**APPLICATION FOR CERTIFICATION
For the *PALMDALE HYBRID
POWER PROJECT***

Docket No. 08-AFC-9

[DRAFT] ERRATA TO THE PRESIDING MEMBER'S PROPOSED DECISION

PROJECT DESCRIPTION - FIGURE 1
Palmdale Hybrid Power Project - Typical Duct Bank Construction Underground Cable Transmission Line

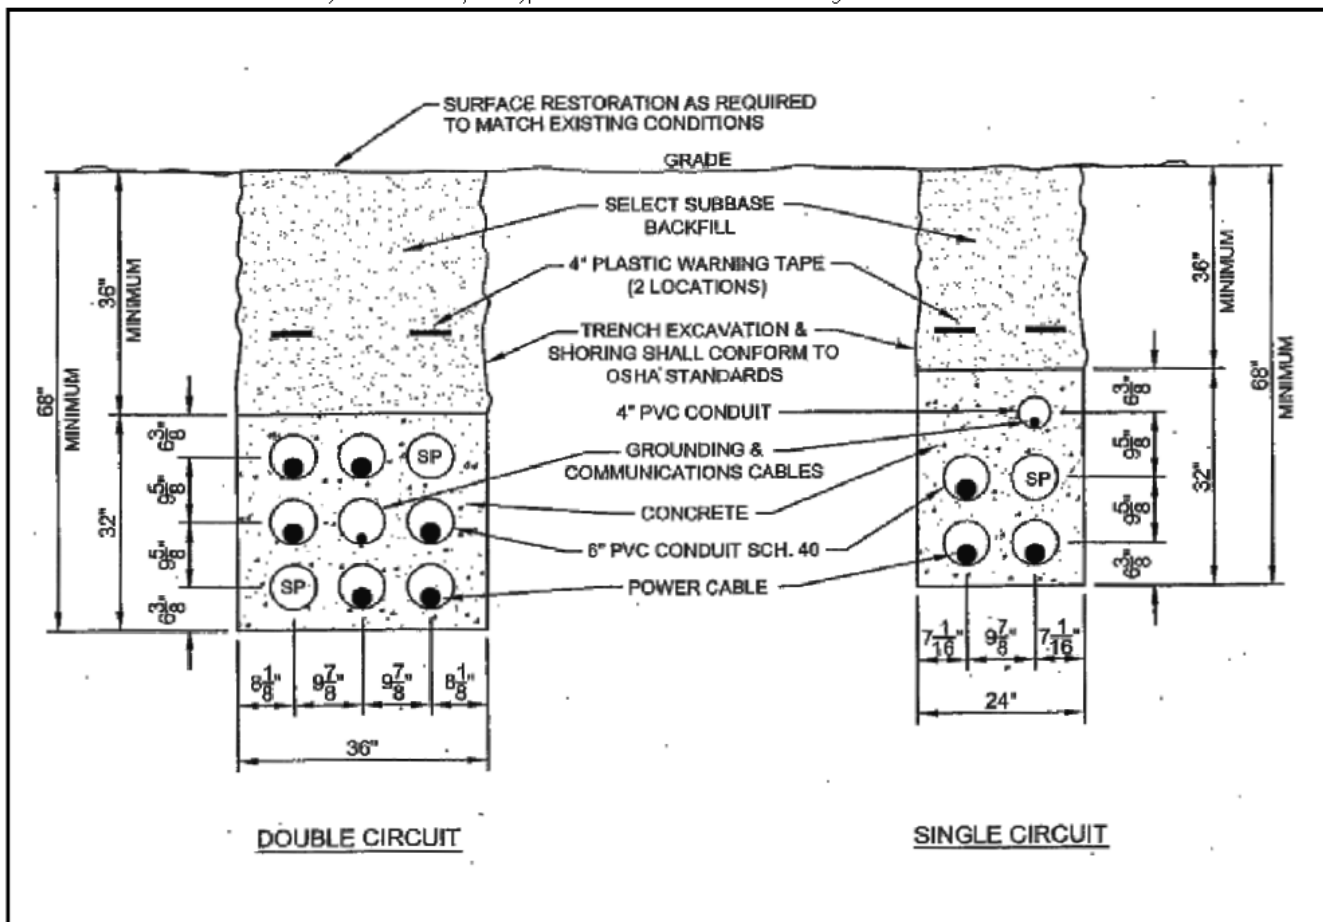
3. Page 5.4-4. Alternatives Appendix A – Figure 1 “Diagram of a Typical Transmission Riser Structure – Palmdale Hybrid Power Plant” should be replaced with Project Description – Figure 1 “Palmdale Hybrid Power Plant – Typical Duct Bank Construction Underground Cable Transmission Line.”

The discussion preceding the figure refers to the Duct Bank Underground Cable Line; however, because both figures were labeled Figure 1 there was apparently some confusion and the PMPD included a diagram of a typical transmission riser structure instead. To avoid any unnecessary confusion, Staff recommends replacing the figure with the correct Figure 1, as follows:
